**COMMANDER 114 SERIES
SERVICE PUBLICATIONS**

The following is a numerical list of all active Service Bulletins.

SERVICE BULLETIN NO. SB-114-1

AILERON CONTROL CHAIN REROUTING

Figure 1.

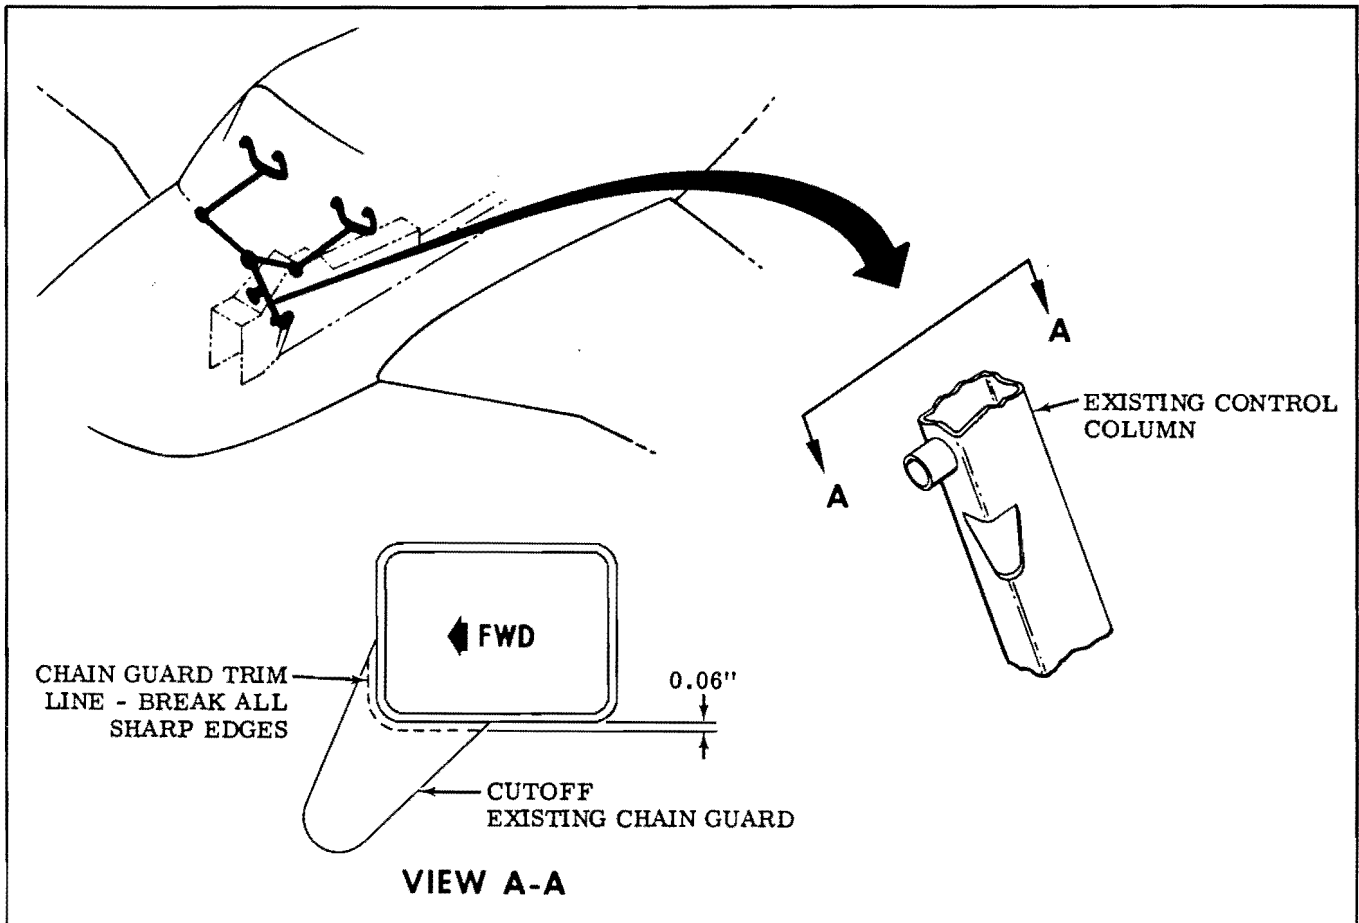
1. Cut off existing chain guard, located on left forward side of control column, as shown in Figure 1.
2. Disconnect right aileron chain at turnbarrel and remove from forward sprocket.
3. Loosen left aileron chain at turnbarrel, remove from aft sprocket and relocate on forward sprocket (see Figure 2.).
4. Relocate right aileron chain on aft sprocket and reconnect to turnbarrel (see Figure 2.).
5. Retighten turnbarrels on both left and right aileron control cables and check all cable tensions as outlined in Airplane Maintenance Manual, Section VII.
6. Check full travel of control column and rudder pedals to assure that no interference exists.
7. Fill out and mail Compliance Card.

Figure 1.

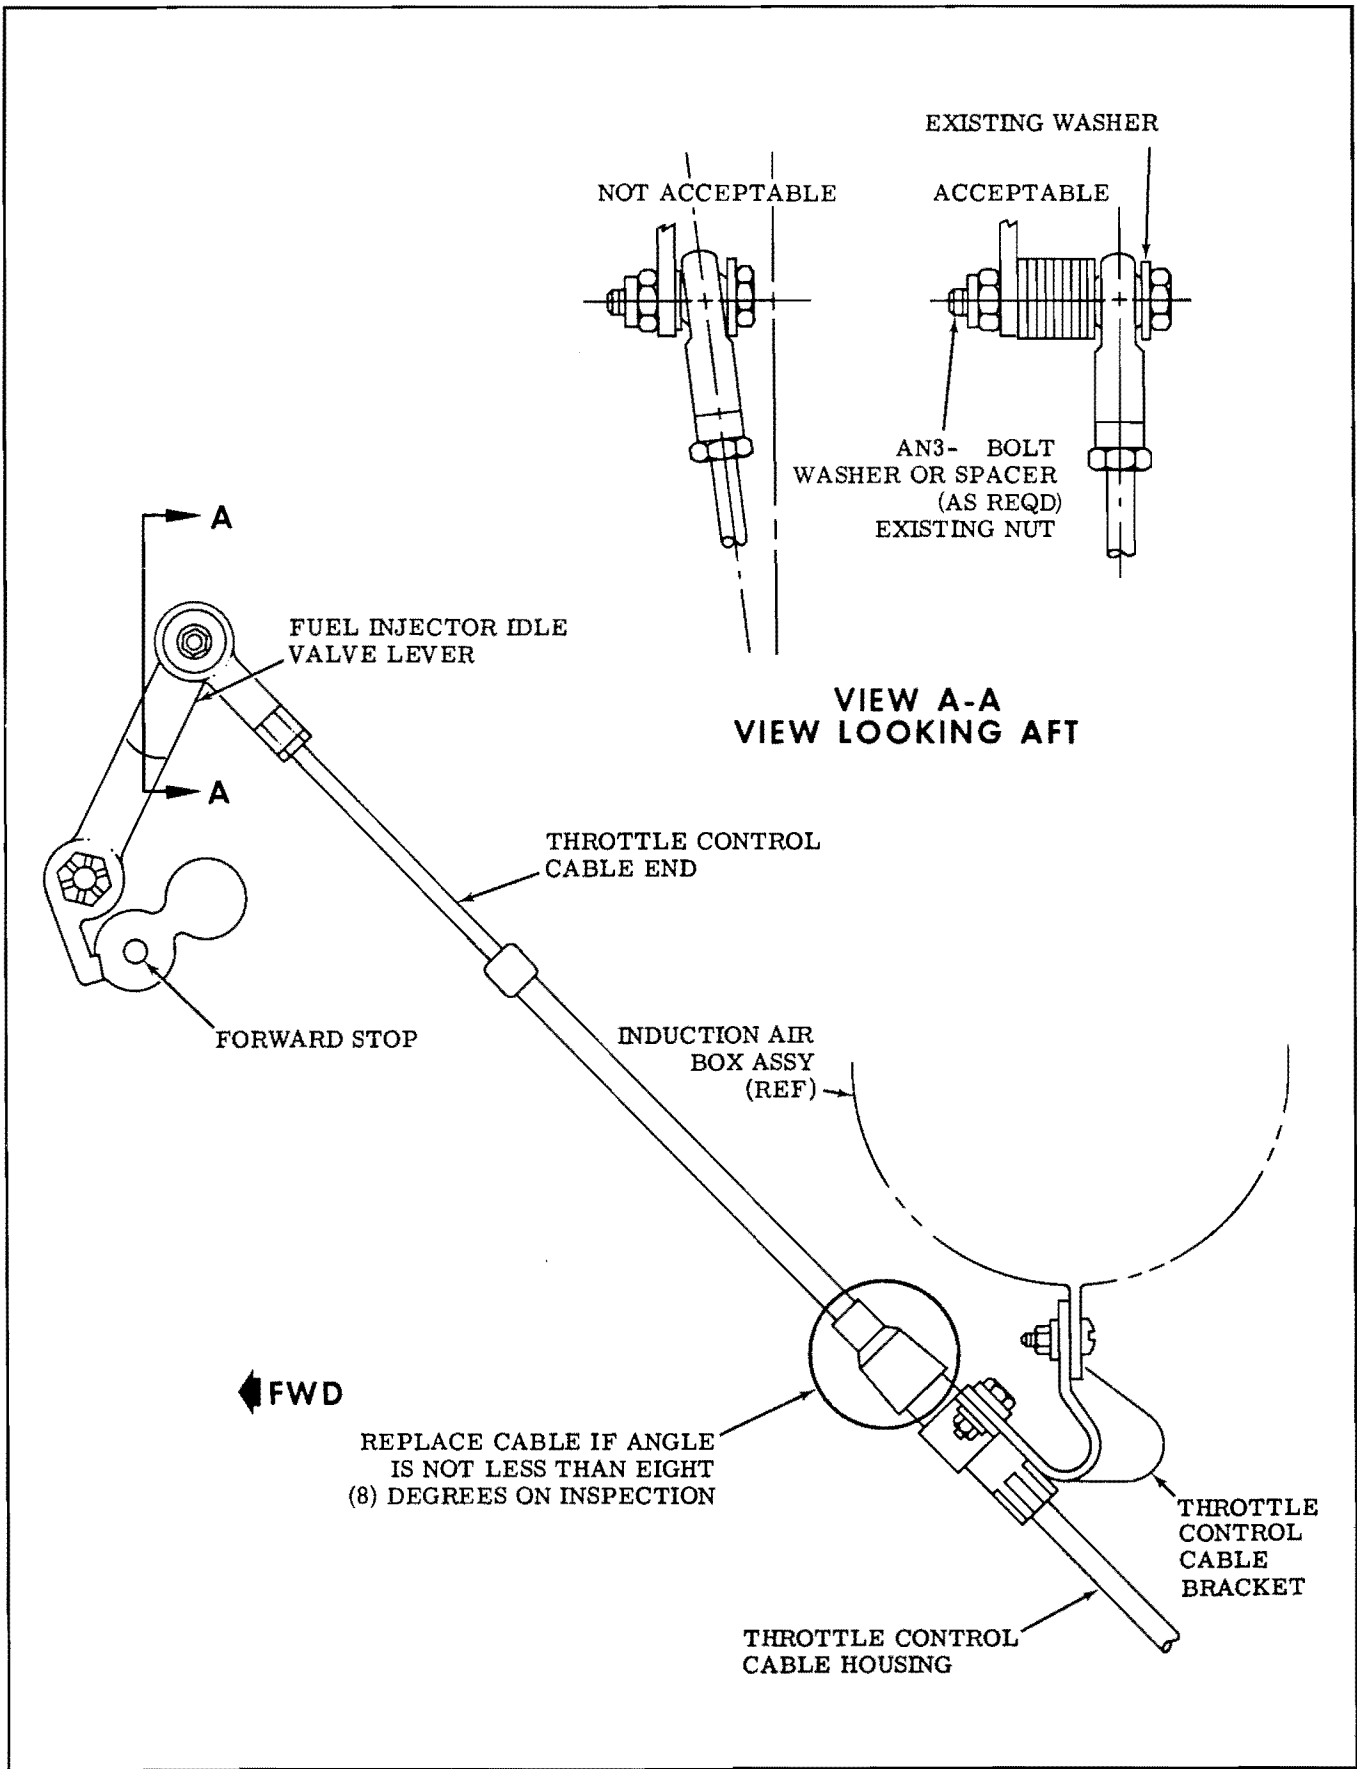
1. Remove upper and lower engine cowling as outlined in the Model 114 Airplane Maintenance Manual, Section IV.
2. Inspect throttle control cable for misalignment. If misalignment is not less than eight (8) degrees (see Figure 1.), replace cable when complying with Part II of this Service Bulletin.
3. With the throttle in mid-point of the stroke, bend throttle control cable bracket as necessary so that cable housing is straight with cable end (see Figure 1.).
4. With the throttle in mid-point of the stroke, inspect throttle control cable at the fuel injector idle valve lever for proper alignment (see Figure 1.).

Figure 1.

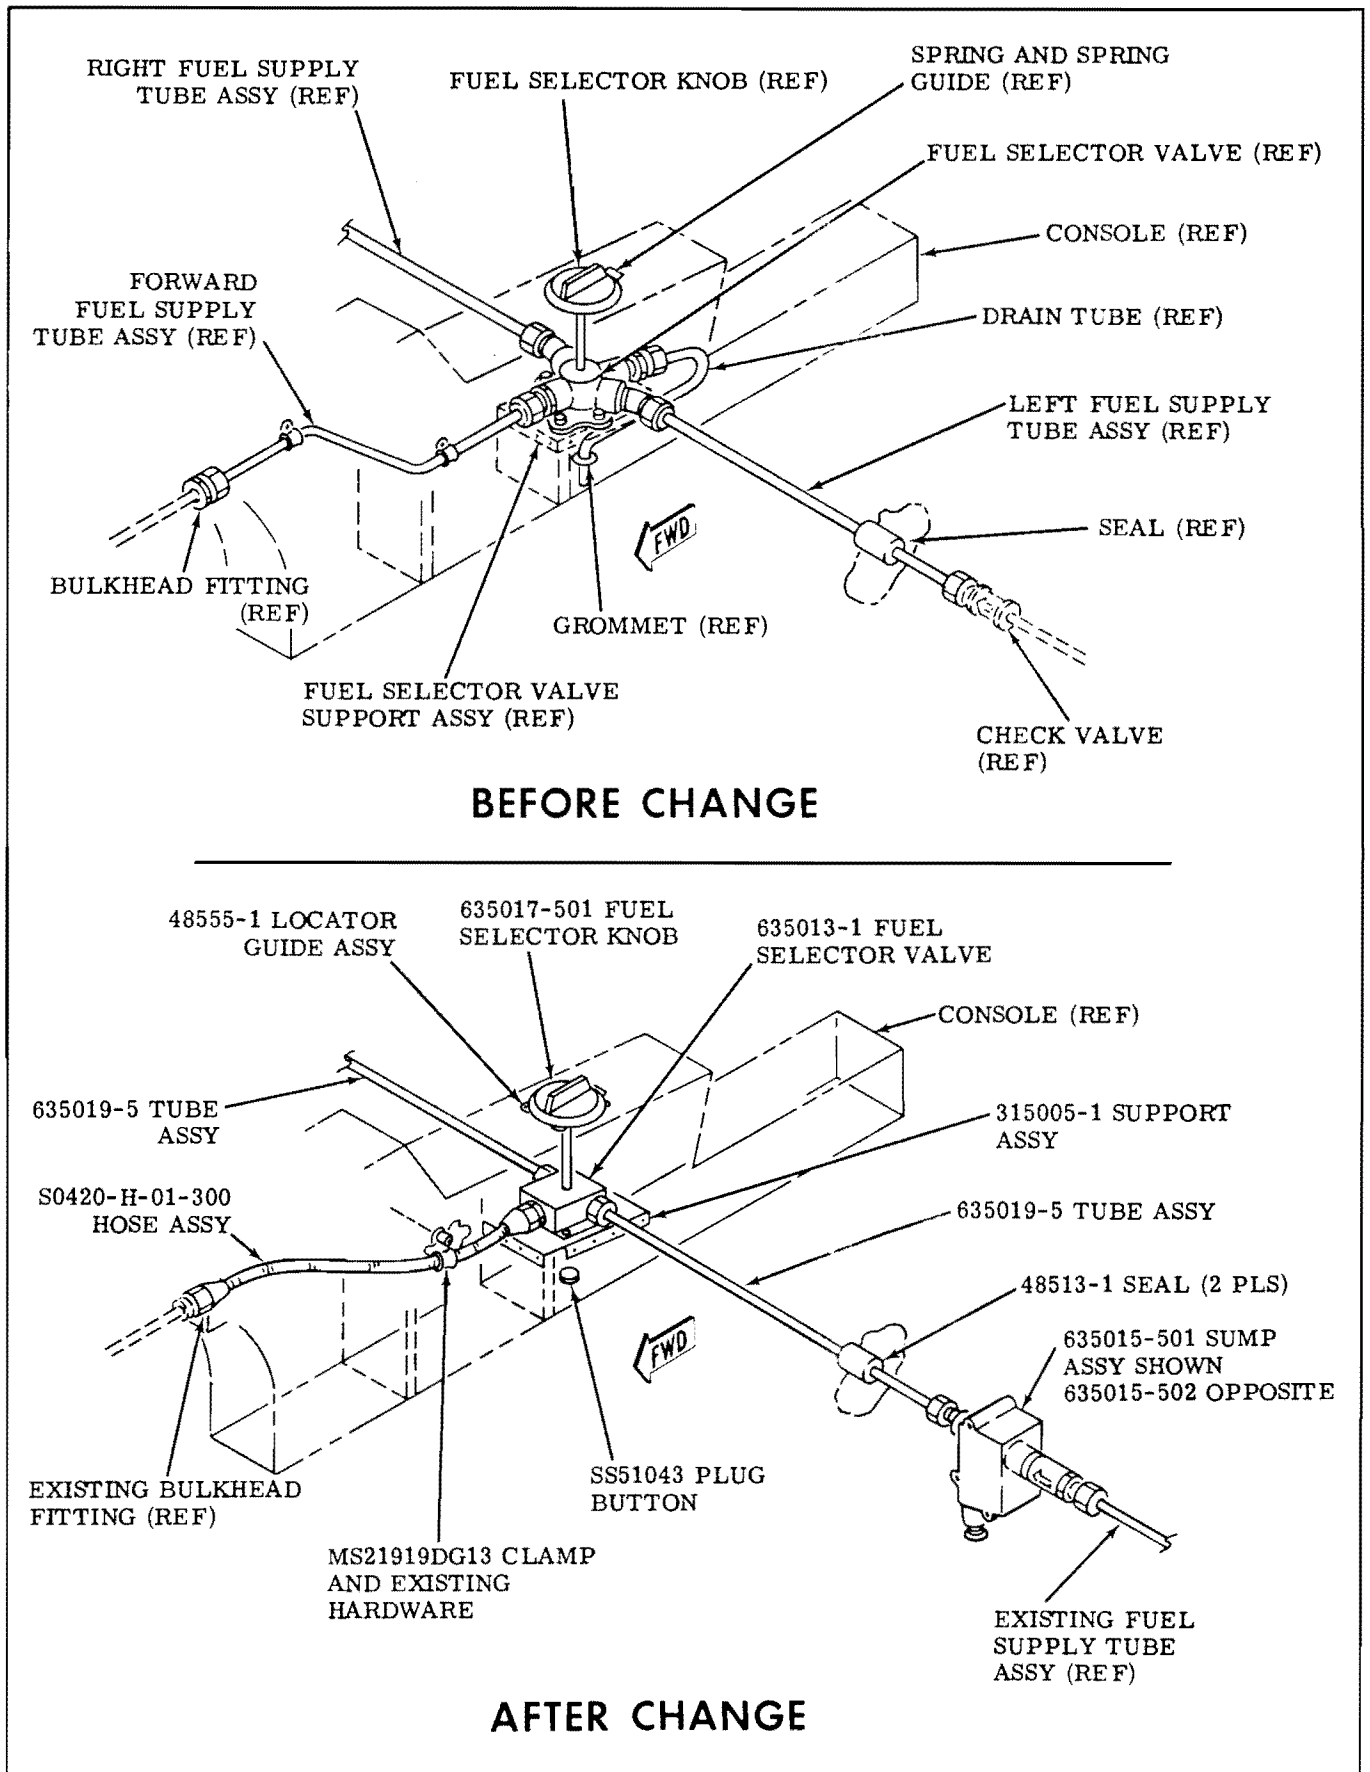
1. Defuel airplane as outlined in the Airplane Maintenance Manual, Section II.
2. Remove pilot and front passenger seats from airplane.
3. Remove and discard existing fuel selector knob assembly from fuel selector valve (see Figure 1.).
4. Remove interior console cover from console.
5. Remove and discard existing bushing from fuel selector valve shaft.
6. Remove metal console covers to gain access to fuel selector valve.
7. Remove carpet from left side of console.
8. Remove and discard existing forward, left and right fuel supply tube assemblies from fuel selector valve and bulkhead fitting (see Figure 1.).

9. Remove and discard existing check valves (if installed) from wheel wells (see Figure 1.).
10. Remove and discard existing fuel selector drain tube and grommet (see Figure 1.).
11. Remove and discard existing fuel selector valve and valve support assembly (see Figure 1.).
12. Plug existing fuel drain hole in lower fuselage skin with SS51043 plug button (see Figure 1.).
13. Enlarge existing fuel line routing holes in left and right side of the console (see Figure 2.).
14. Enlarge hole in forward frame of console to clear fitting on S0420-H-01-300 hose assembly (see Figure 3.).
15. Enlarge fuel line routing holes and brake line routing holes in left and right wing ribs (WS 26.50) (see Figure 2.).

16. Connect the forward end of S0420-H-01-300 hose assembly to the existing bulkhead fitting (see Figure 1.).

Figure 4.

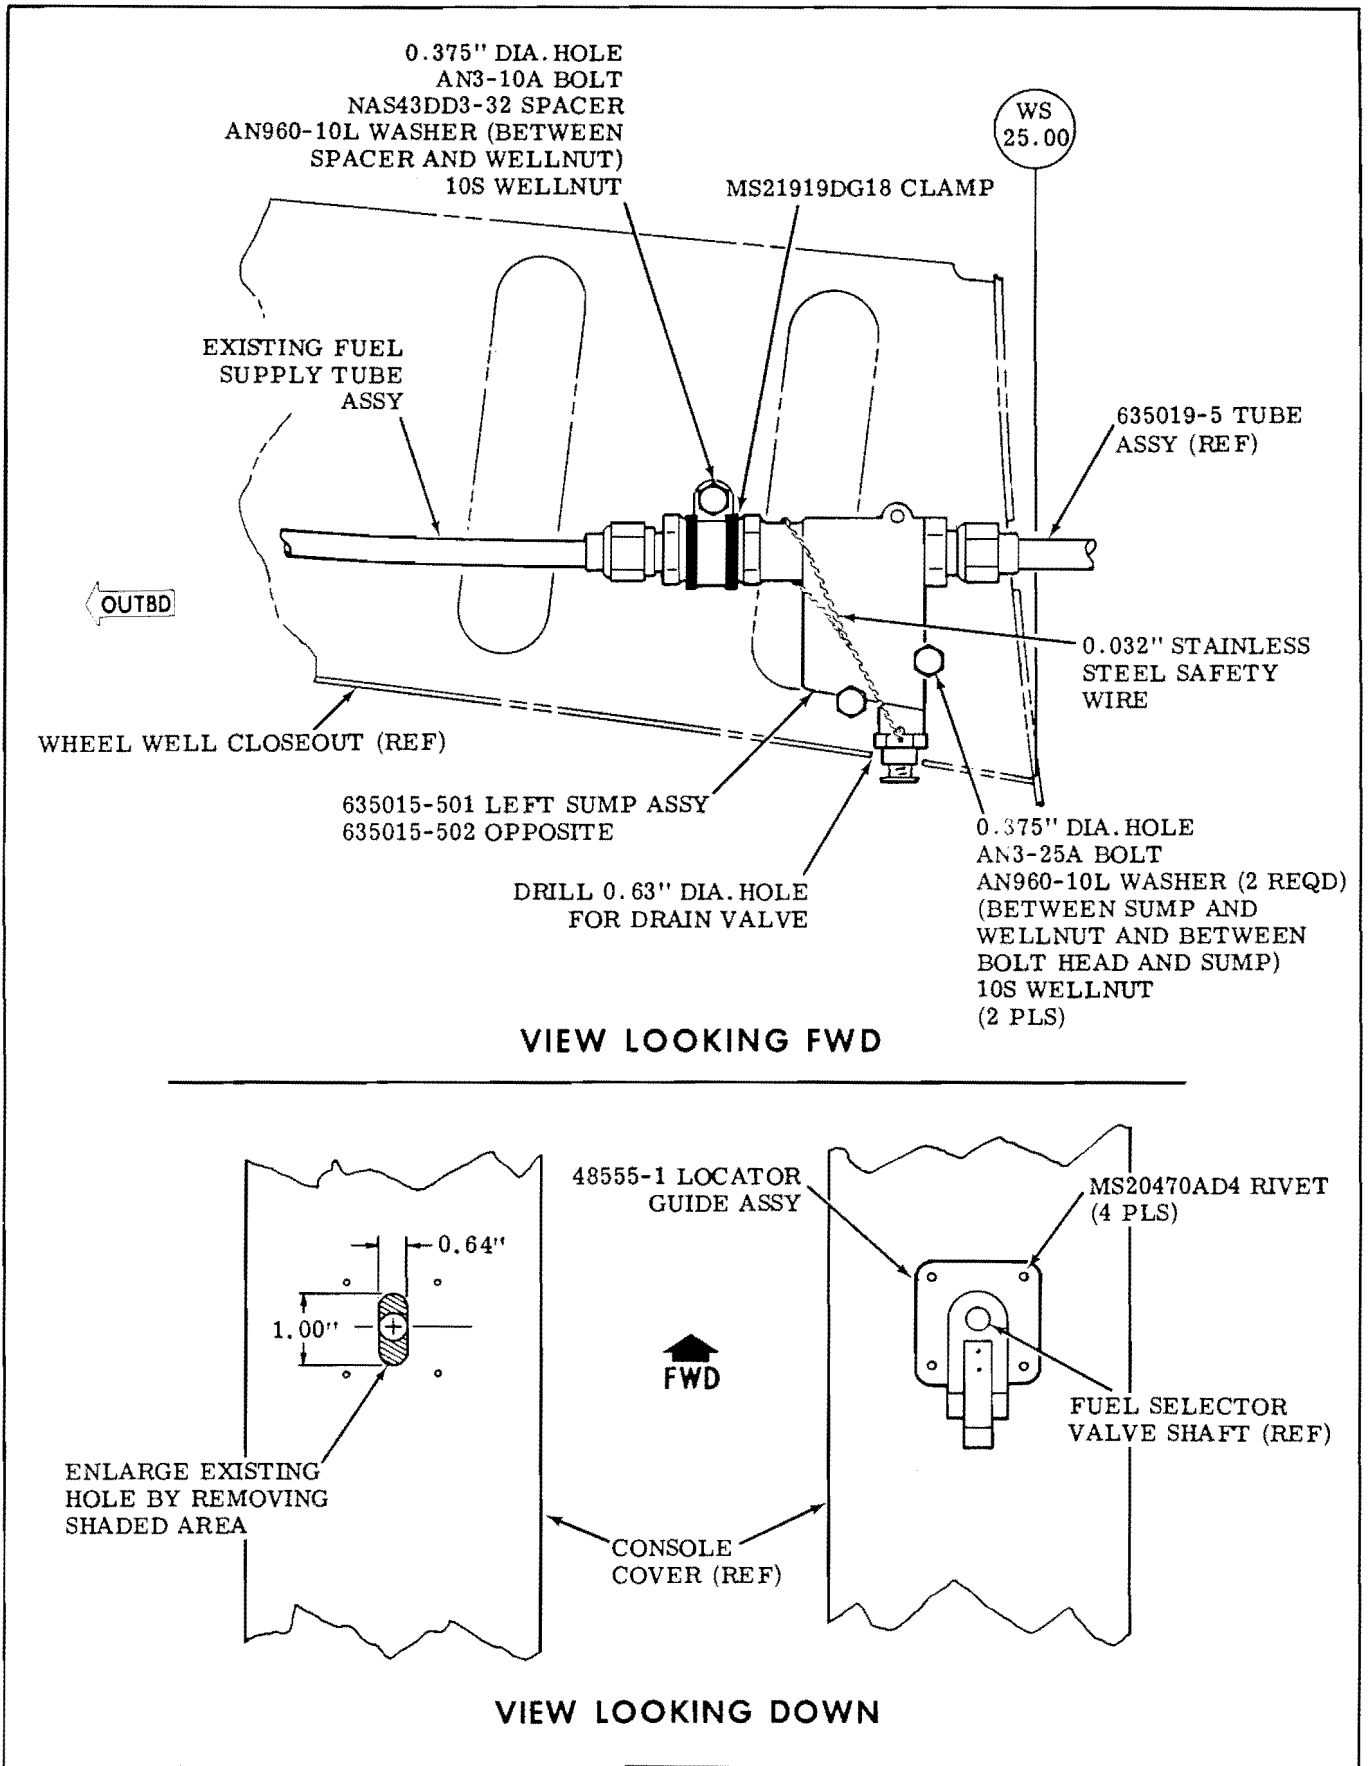
25. With fuel sumps positioned in location to assure fuel lines will drain into them, pilot drill (No.10 drill) two (2) lower holes only in wheel well closeout for attaching 635015-501 left fuel sump assembly and 635015-502 right fuel sump assembly (see Figure 4.).

26. Install MS21919DG18 clamp on sump assembly check valve and pilot drill (No. 10 drill) attaching hole in wheel well closeouts (see Figure 4.).
27. Locate and drill a 0.63-inch diameter hole in left and right lower wing skins for fuel sump drain (see Figure 4.).

28. Remove fuel sumps from airplane and reinstall drain valves and existing O-rings in fuel sumps and safety wire drain valves with 0.032-inch diameter stainless steel safety wire (see Figure 4.).

29. Enlarge holes, drilled in steps 25. and 26., to 0.375-inch diameter (see Figure 4.).
30. Install 10S wellnut (6 places) on wheel well closeouts (see Figure 4.).

38. Enlarge existing 0.64-inch diameter hole in metal console cover (see Figure 4.).
39. Temporarily install existing metal console cover on console.

40. Locate 48555-1 locator guide assembly on metal console cover and mark location of attaching holes for guide assembly (see Figure 4.).

41. Remove locator guide assembly and metal console cover from console. Drill and install locator guide assembly on metal console cover (see Figure 4.).
42. Install metal console cover on console with existing hardware.
43. Reinstall existing carpet on left side of console with 3642A Tuf-Grip or 3M EC1300 cement or equivalent.
44. Reinstall interior console cover on console with existing hardware.
45. Install 635017-501 fuel selector valve knob on fuel selector valve shaft (see Figure 1.).
46. Reinstall pilot and front passenger seats in airplane.
47. Fill out and mail Compliance Card.
